MFN 07-294

Subject: **Response to Portion of NRC Request for Additional Information  
Letter No. 97 Related to ESBWR Design Certification Application –  
Electrical Power - RAI Numbers 8.3-56, 8.3-57, and 8.3-58**

**Response to Portion of NRC Request for Additional  
Information Letter No. 97 Related to ESBWR Design  
Certification Application – Electrical Power - RAI Numbers  
8.3-56, 8.3-57, and 8.3-58**

Figure 7.2-1. RPS Functional Block

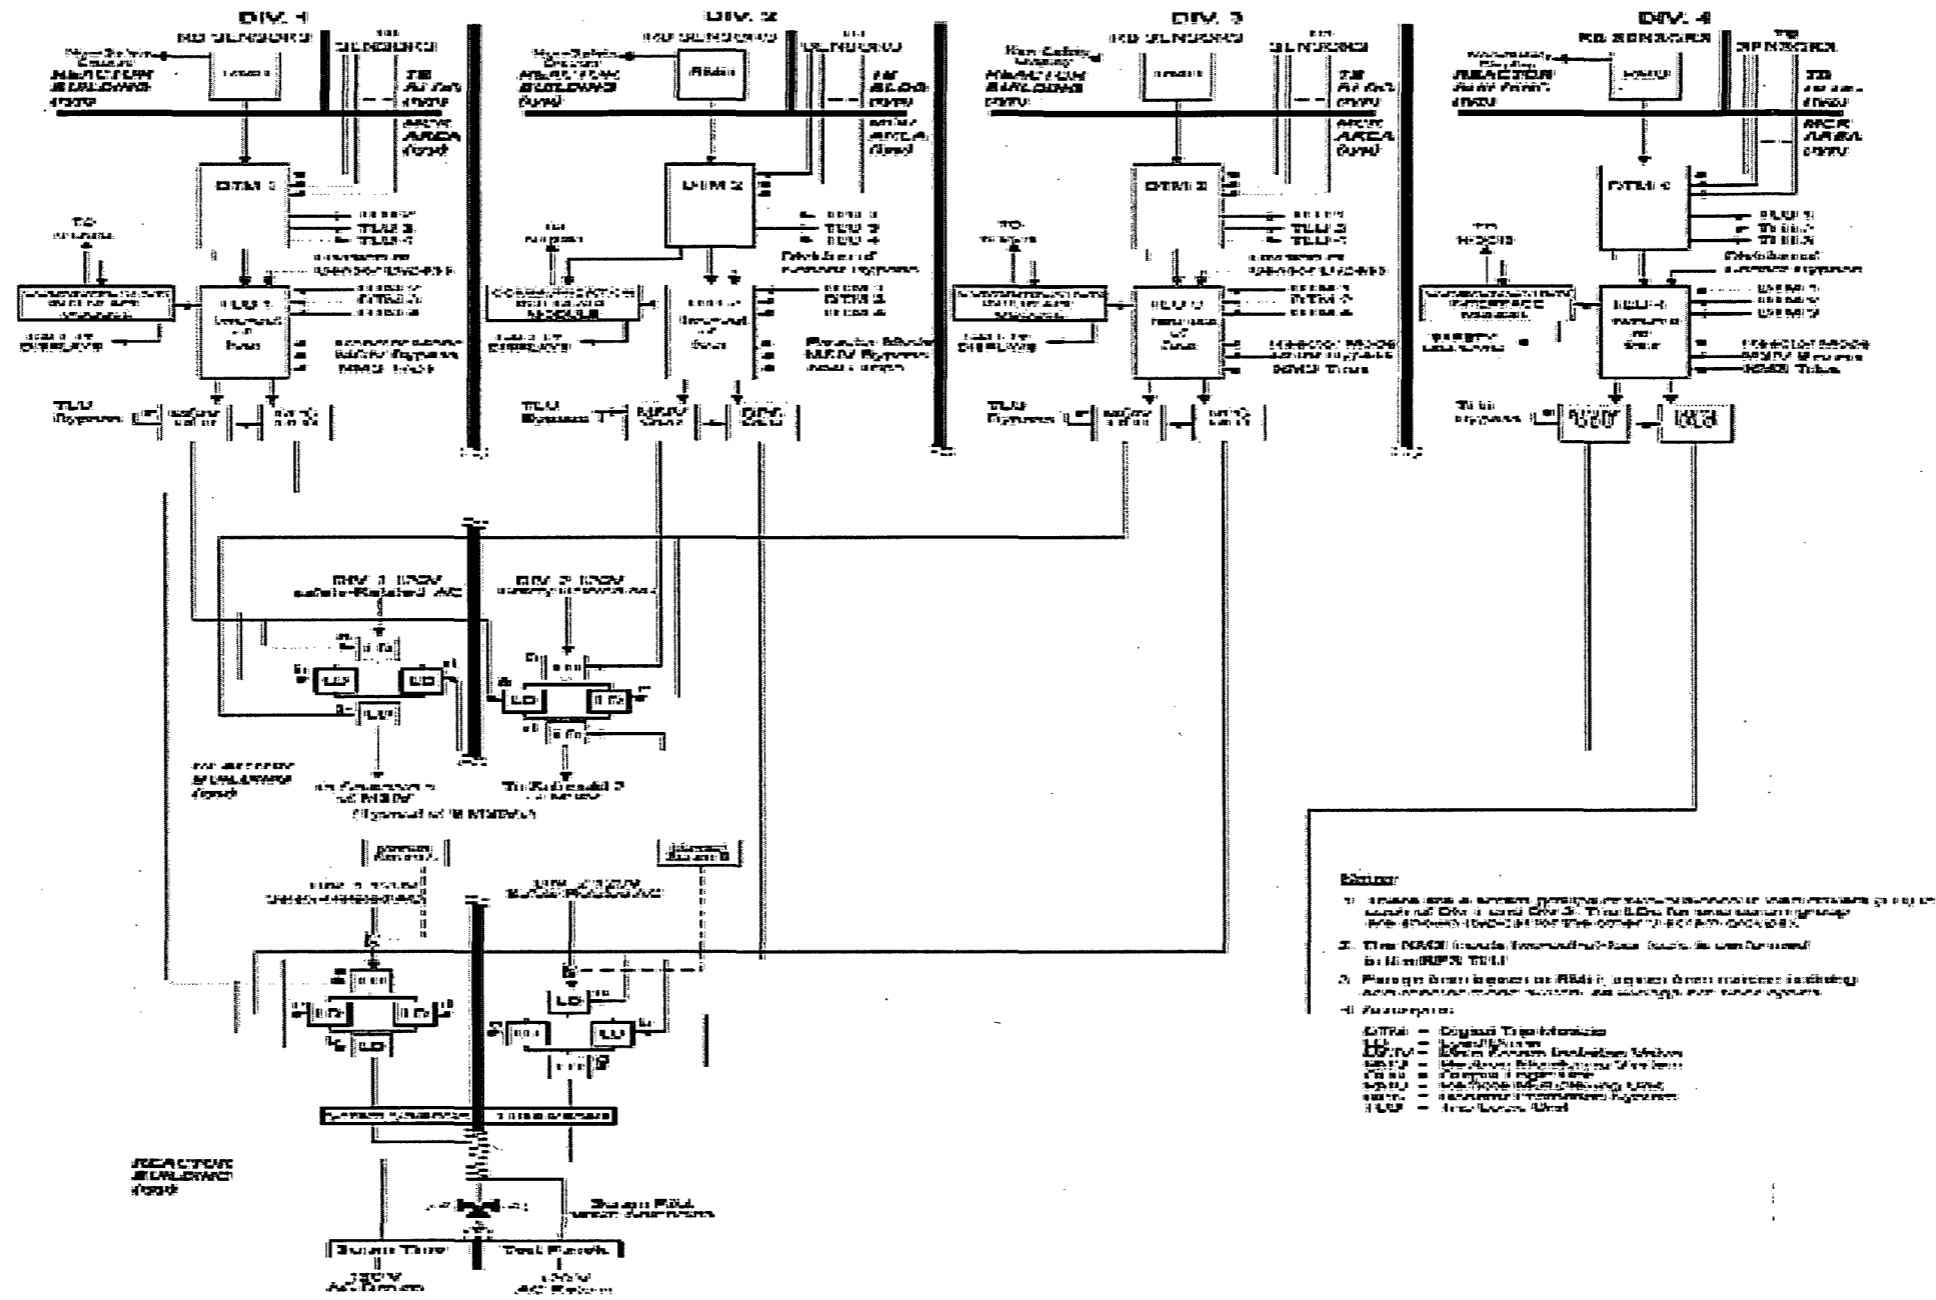
*Four divisions of safety-related UPS provide 120V AC power for the reactor protection systems (RPS). Fig. 8.1-4 in Revision 3 of DCD indicated that two RPS power feeders from division 1, two RPS power feeders from division 2, and none from divisions 3 and 4. During a public meeting on April 25 and 26, 2007, GE clarified that RPS instrumentation is powered by four divisions of power from Q-DCIS, but reactor trip solenoids are only powered by division 1 and division 2, due to the fail safe configuration (lost power to scram reactor). Fig. 8.1-4 should be revised to show those power feeders to "Scram solenoids" rather than "RPS".*

GE has attached the Chapter 7 Revision 3 Fig. 7.2-1 RPS Functional Block to more clearly depict the two power feeders from division 1 and two power feeders from division 2 are only called "RPS". The two feeders from each division feed the load driver series/parallel switches for divisions 1 and 2 RPS sections of the DCIS. There are two sets of load drivers in each division 1 and 2 for not only the scram solenoids but also the MSIV solenoids. GE prefers to retain the feeder load as "RPS" and not designate one feeder as "RPS Scram Solenoids" and the other as "MSIV Solenoids" since both of the feeders go to the respective load drivers of divisions 1 and 2 RPS Q-DCIS.

No additional DCD changes will be made in response to this RAI.
